# ***Value Engineering Study Report***

## ***SR 8/US 78 at Mann Road/Mason Creek Road and at Post Road Intersection Improvements, Douglas County CSSFT-0008-00(375), PI No. 0008375***

***February 2012***

Subject: Final Value Engineering Study Report  
***SR 8/US 78 at Mann Road/Mason Creek Road and at Post Road  
Intersection Improvements, Douglas County, CSSFT-0008-00(375)  
PI No. 0008375***

# VE ALTERNATIVE A-6

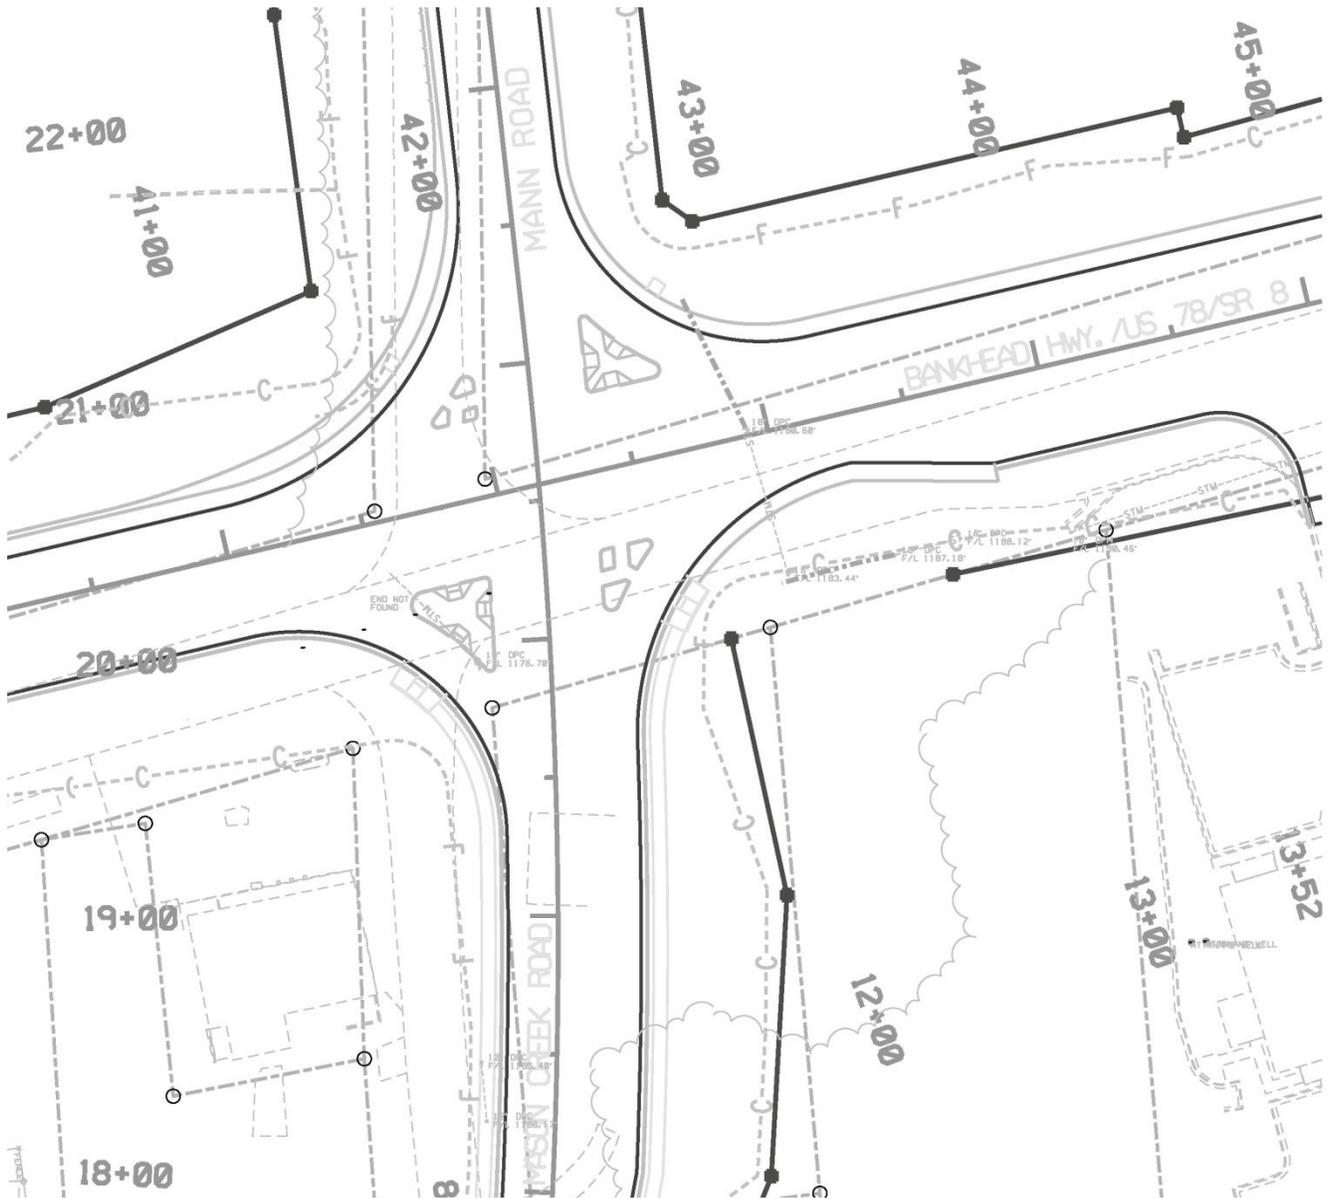
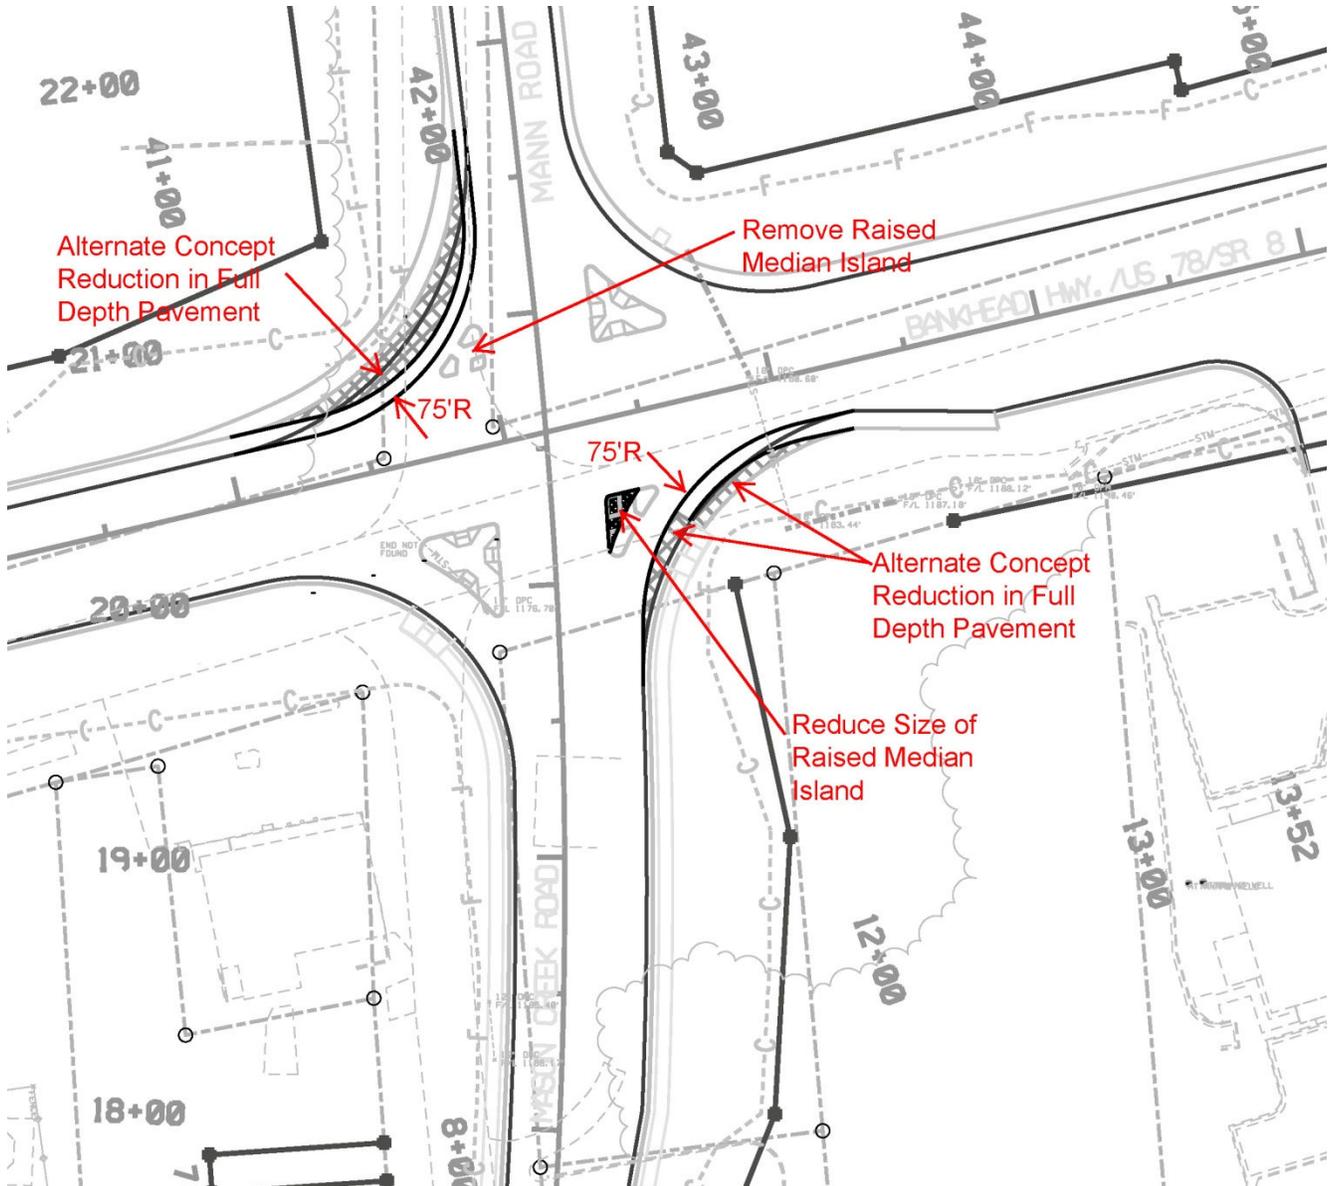
**Discussion:** The GDOT *Driveway Manual* indicates that radius returns should be a minimum of 75 feet when designing for trucks. The percent of truck volume along Bankhead Highway is moderate at 7%. The large 100+ foot radius returns provide an illusion that a free flow or yield condition is present for the right turn movements. Since a traffic signal is proposed to be installed at this intersection, right-turning vehicles will need to stop on red to determine if they can proceed with the right turn. The reduced radius will facilitate this direction and will provide right-turning drivers better visibility to cars approaching from the left since the approach angle will not be flattened as much as with the larger radii.

Reduce the radius on the corners of Bankhead Highway/Mason Creek Road down to 75 feet

## VE ALTERNATIVE A-7

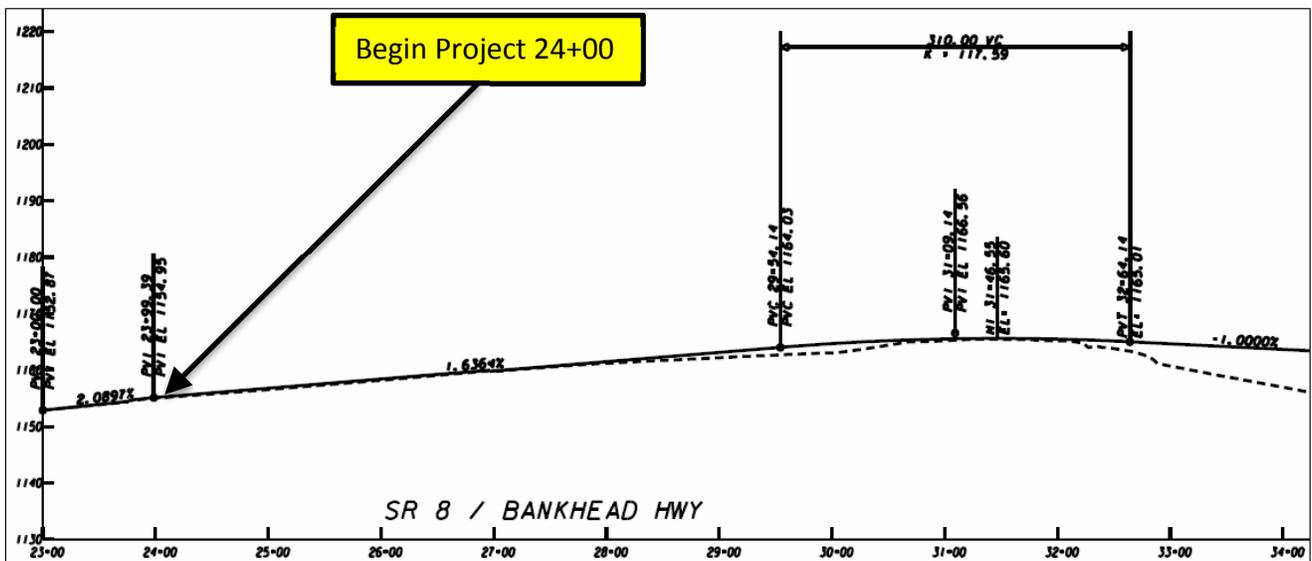
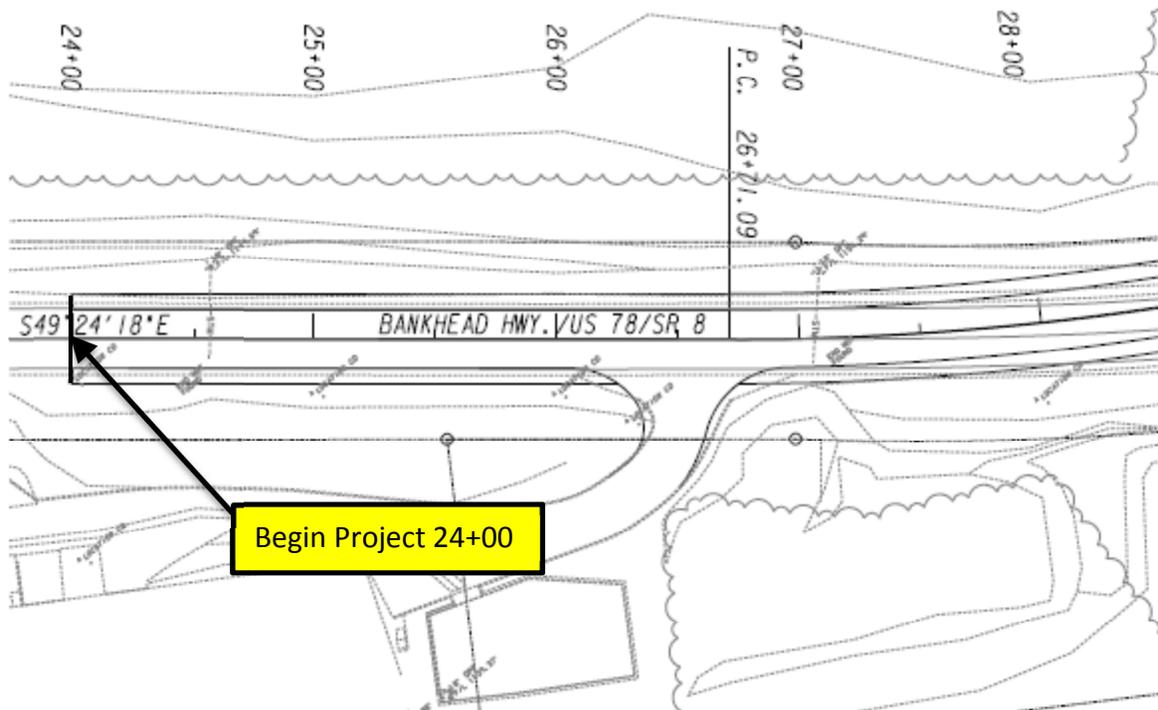
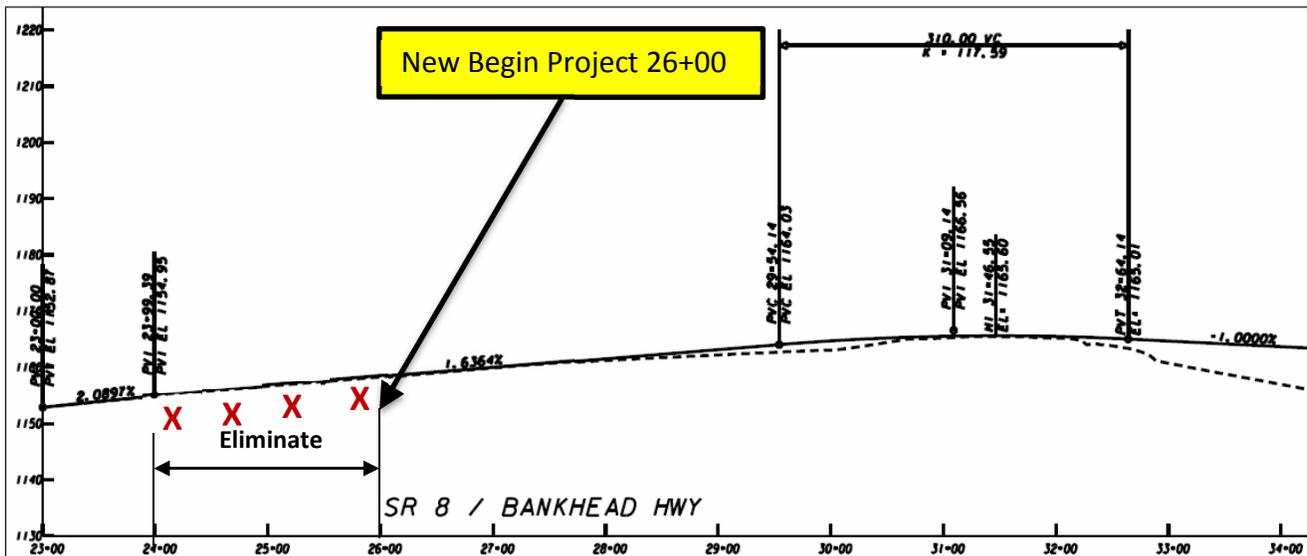
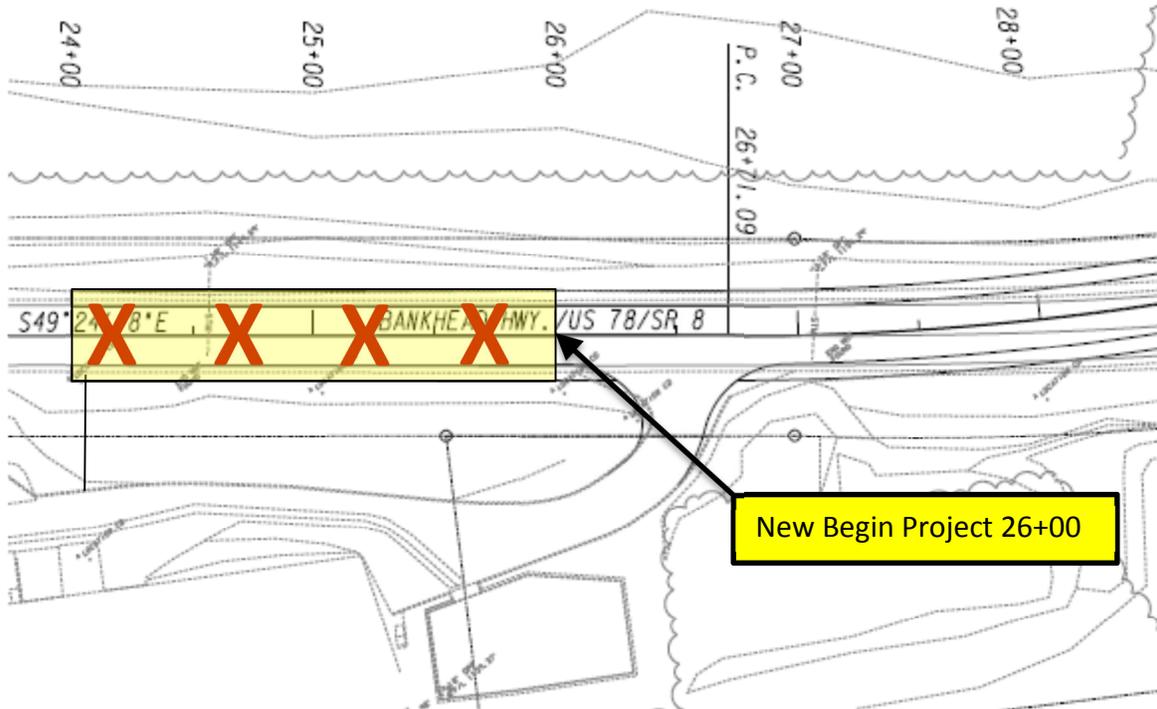
The project limit on the west end of Bankhead Highway appears to follow the existing alignment and profile for the last 200 feet, basically resulting in a skimming operation for paving. This appears to add very little value to the project unless the existing pavement is failing and in need of total replacement.

This alternative shifts the beginning project station to 26+00, but consider shifting this further to just before the commercial driveway and potentially placing the beginning project station at STA 26+71. Review maintenance of traffic plans with the combination of these changes and using full depth pavement through the merge of the existing pavement and proposed.

Review maintenance of traffic plans and consider the commercial driveway owner as to what they may prefer for either some modification to their entrance or none at all.

Shorten the project limits on the west end of Bankhead Highway from STA 24+00 to 26+00

## VE ALTERNATIVE A-8

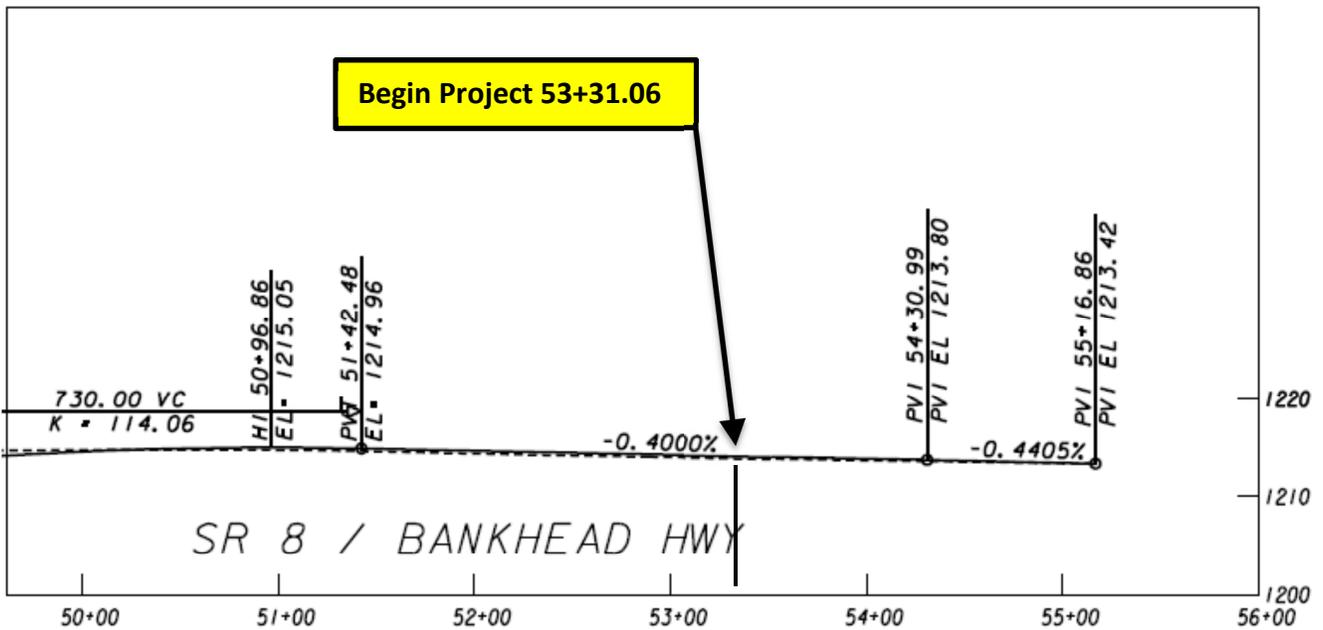
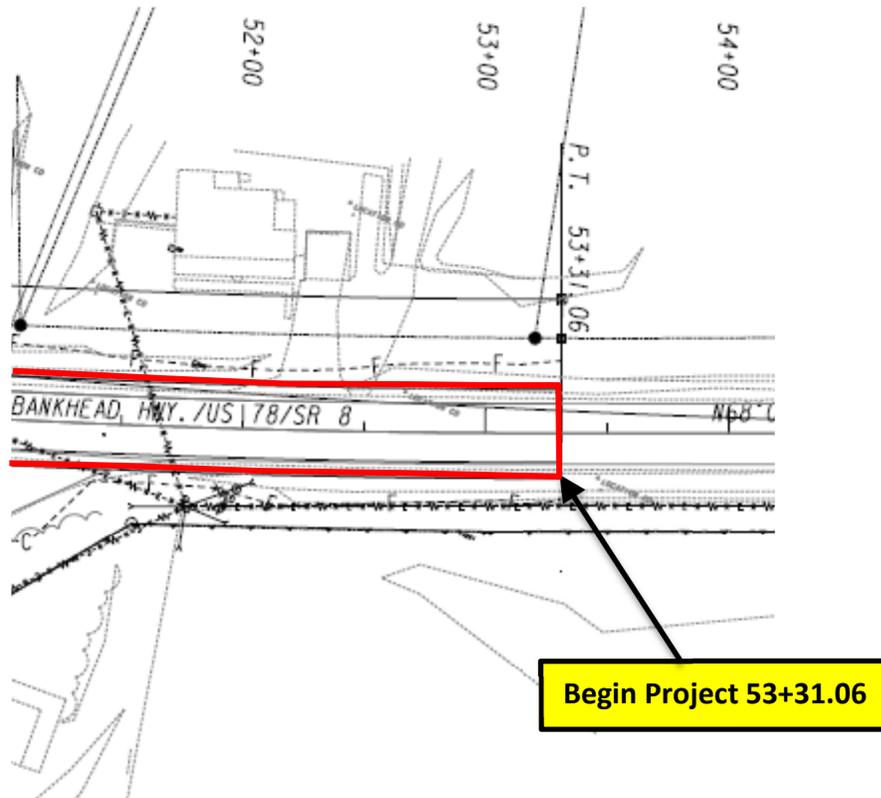
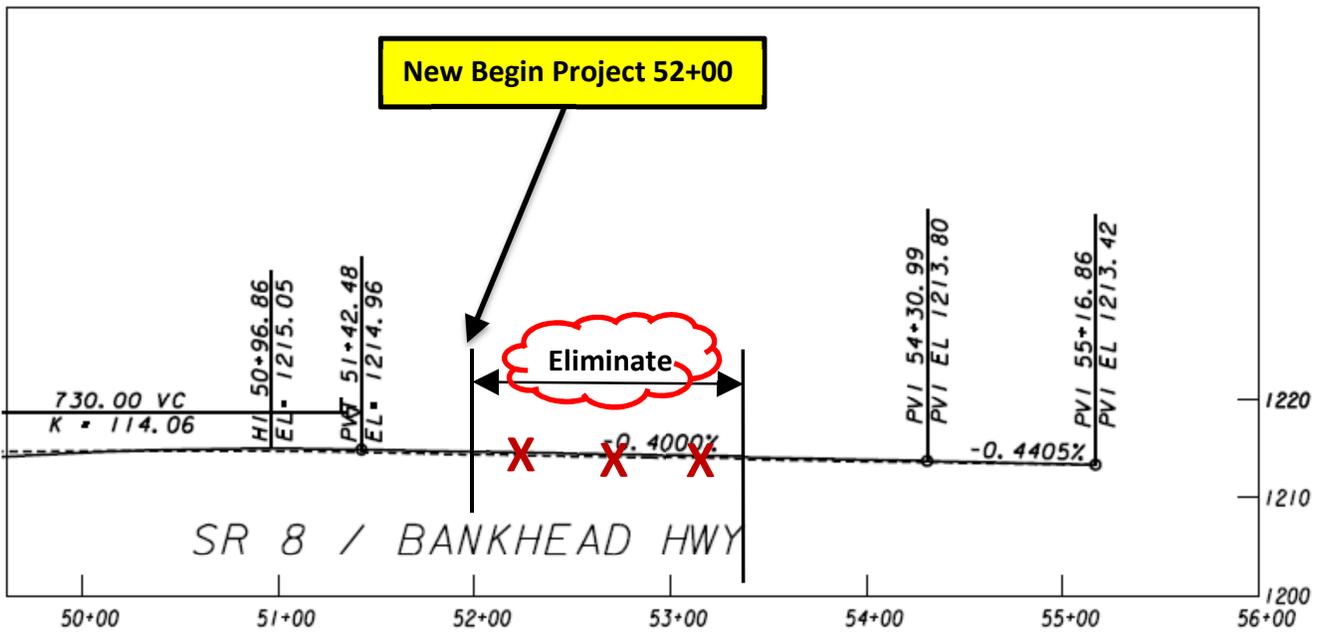
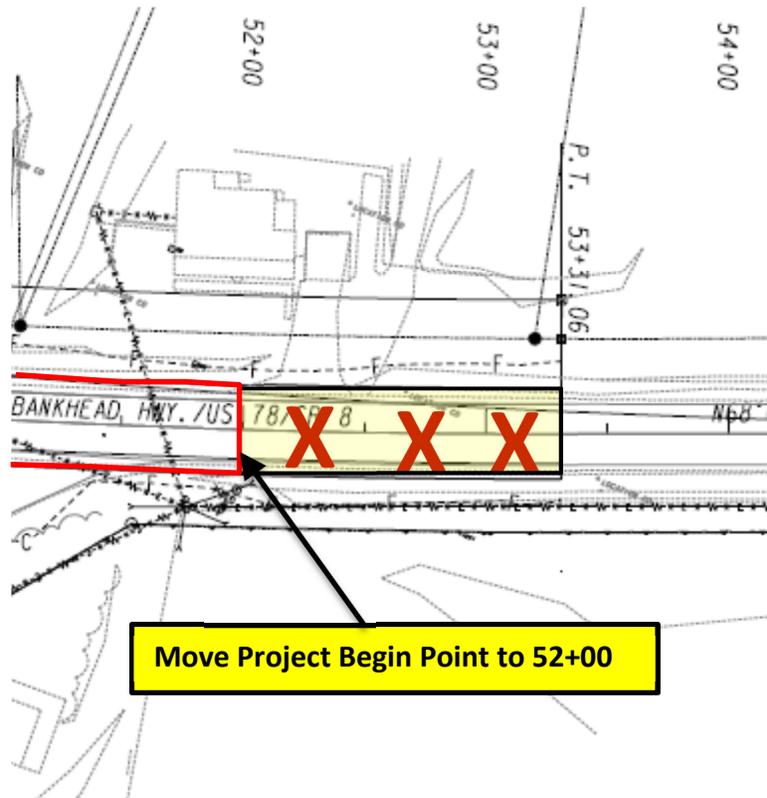
Similar to Alternative A-7, the alignment and profile on the east end of the project appear to simply replace the existing pavement section. Unless there is a requirement to replace the pavement, it is recommended that the project limits be reduced.

Review maintenance of traffic plans with the combination of these changes and using full depth pavement through the merge of the existing pavement and proposed.

Review maintenance of traffic plans and consider the commercial driveway owner as to what they may prefer for either some modification to their entrance or none at all.

Shorten the east end of the project on Bankhead Highway from STA 53+31 to 52+00
